March 1, 2019

LS Power Grid New York, LLC (f/k/a North America Transmission, LLC) and the New York Power Authority appreciate the opportunity for stakeholder review and comment on the Addendum to the AC Transmission Public Policy Transmission Planning Report dated December 27, 2018.

Comments of LS Power and the New York Power Authority on the AC Addendum February 26, 2019

SUBJECT: 153160 NY AC Transmission NYISO PPTP Report Response on Resilience

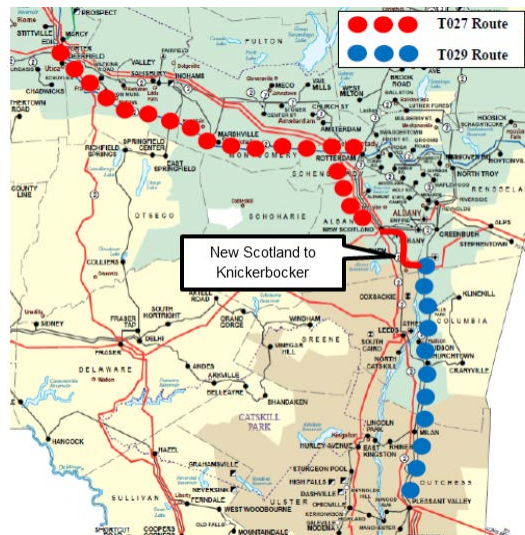
However, properly modeled, T027+T029 should have greater production cost benefits than Proposals T027+T019. The production cost savings for both proposals is shown to be limited by congestion on the New Scotland to Knickerbocker path, which is located between Segment A and Segment B as shown in the figure below.

Figure 1: Incremental Benefits of Additional Capacity on the UPNY-SENY Interface

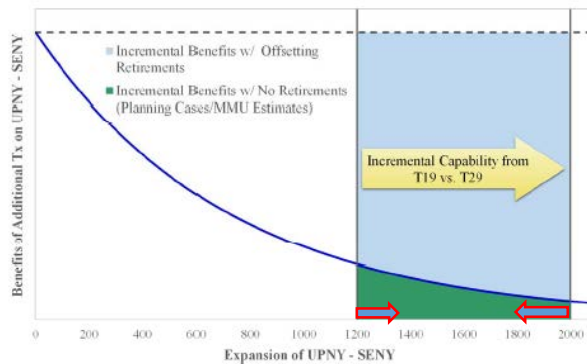
The revised Addendum, dated February 20, 2019 recognizes differences in the transfer capability from the Addendum dated December 27, 2019 would reduce the ICAP benefits, but additional analysis was not performed to identify the precise level of ICAP benefits. Instead, the February Addendum only states that the change in results would have a “corollary effect on the ICAP savings differential” (p. 28). The figure below attempts to illustrate this effect. The figure below is Figure 1 from the MMU November 8, 2018 memo to the NYISO Board of Directors. It identifies increasing benefits of expansion of UPNY-SENY. The red arrows have been added to show

the change in capability from the December 27, 2019 to the February 20, 2019, from 1150 MW to 1300 MW for Proposal T029, and from 2100 MW to 1850 MW for Proposal T019. In order to estimate the impact of the change in capacity a simple linear interpolation can be made. Note that this conservative methodology does not account for diminishing marginal returns or limitations that arise from UPNY-ConEd.³ The table below estimates the NPV of ICAP benefits for each project based on a linear interpolation of the values in the December 27, 2019 Addendum updated for the February 2019 capability values.
